Access Compliance Report

Public Rights-of-Way

(Pedestrian Signals)

Intersection ID: N/A	Main Street:	Cross Street: N/A	Location: N/A
ADA ID: 7E55D498C3F6	Signal Type: Two Push Buttons-APS	Overall Compliance: No	Severity Score: BTN 1:N/A BTN 2: N/A No BTN: N/A
Codes/Mitigation Info/Possible Solution		Field Measurements/Component Compliance

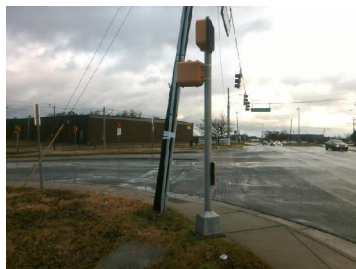
PROW/ADA: TMUTCD 4e.08, R404.2, R406.2,

Compliance	Description	Data	Compliance	Description	Data
	Button Count	Button2	N/A	Distant to Additional Button (in)	N/A
	Additional Button Present?	No		Additional Button ID	N/A
N/A	Signal Buttons Required?	N/A	N/A	Additional Ped Posts Required	N/A
	How Many Ped Street Xings?	2		Located In An Island/Median?	No
N/A	B 1 Sign Present?	Yes	N/A	B 2 Sign Present?	Yes
Yes	B 1 Sign Purpose?	Yes	Yes	B 2 Sign Purpose?	Yes
Yes	B 1 Sign Lettering & Contrast?	Yes	Yes	B 2 Sign Lettering & Contrast?	Yes
Yes	B 1 Parallel To XWalk?	Yes	Yes	B 2 Parallel To XWalk?	Yes
Yes	B 1 PAR to Button?	Yes	Yes	B 2 PAR to Button?	Yes
Yes	B 1 PAR to XWalk?	Yes	Yes	B 2 PAR to XWalk?	Yes
Yes	B 1 Clear Floor Space?	Yes	Yes	B 2 Clear Floor Space?	Yes
N/A	B 1 FWD Approach?	Yes	N/A	B 2 FWD Approach?	Yes
N/A	B 1 FWD Approach Constrained?	No	N/A	B 2 FWD Approach Constrained?	No
No	B 1 FWD Approach Reach (in)	11.0	No	B 2 FWD Approach Reach (in)	9.0

N/A	B 1 FWD Approach Width (in)	N/A	N/A	B 2 FWD Approach Width (in)	N/A
N/A	B 1 FWD Approach Obstruction?	Yes	N/A	B 2 FWD Approach Obstruction?	Yes
N/A	B 1 FWD Approach Obstruction Dist (in)	2.0	N/A	B 2 FWD Approach ObstructionDist (in)	1.0
N/A	B 1 PARA Approach?	Yes	N/A	B 2 PARA Approach?	Yes
N/A	B 1 PARA Approach Constrained?	No	N/A	B 2 PARA Approach Constrained?	No
Yes	B 1 PARA Approach Reach (in)	8.0	Yes	B 2 PARA Approach Reach (in)	7.0
N/A	B 1 PARA Approach Width (in)	N/A	N/A	B 2 PARA Approach Width (in)	N/A
N/A	B 1 PARA Approach Obstruction?	Yes	N/A	B 2 PARA Approach Obstruction?	Yes
N/A	B 1 PARA Approach Obstruction Dist (in)	2.0	N/A	B 2 PARA Approach ObstructionDist (in)	1.0
Yes	B 1 Clear Floor Space Slope (%)	2.0	Yes	B 2 Clear Floor Space Slope (%)	1.8
No	B 1 Clear Floor Space XSlope (%)	2.4	No	B 2 Clear Floor Space XSlope (%)	3.0
N/A	B 1 PAR Slope (%)	0.4	N/A	B 2 PAR Slope (%)	3.5
Yes	B 1 Height (in)	41.0	Yes	B 2 Height (in)	40.5

Yes	B 1 Clear Xing Direction?	ClearlyMarked	Yes	B 2 Clear Xing Direction?	ClearlyMarked
	B 1 Crossing Direction	To E		B 2 Crossing Direction	To N
Yes	B 1 DistanceTo XWalk (in)	0.0	Yes	B 2 DistanceTo XWalk (in)	0.0
No	B 1 DistanceTo Curb (in)	73.0	Yes	B 2 DistanceTo Curb (in)	72.0
Yes	B 1 Diameter (in)	2.0	Yes	B 2 Diameter (in)	2.0

Possible Solutions: Replace Signal Push Button With APS Button on New Post.
Remove & Relocate Sign. Remove & Replace
Replace APS Button With New APS Button.
Remove and Replace Clear Space.
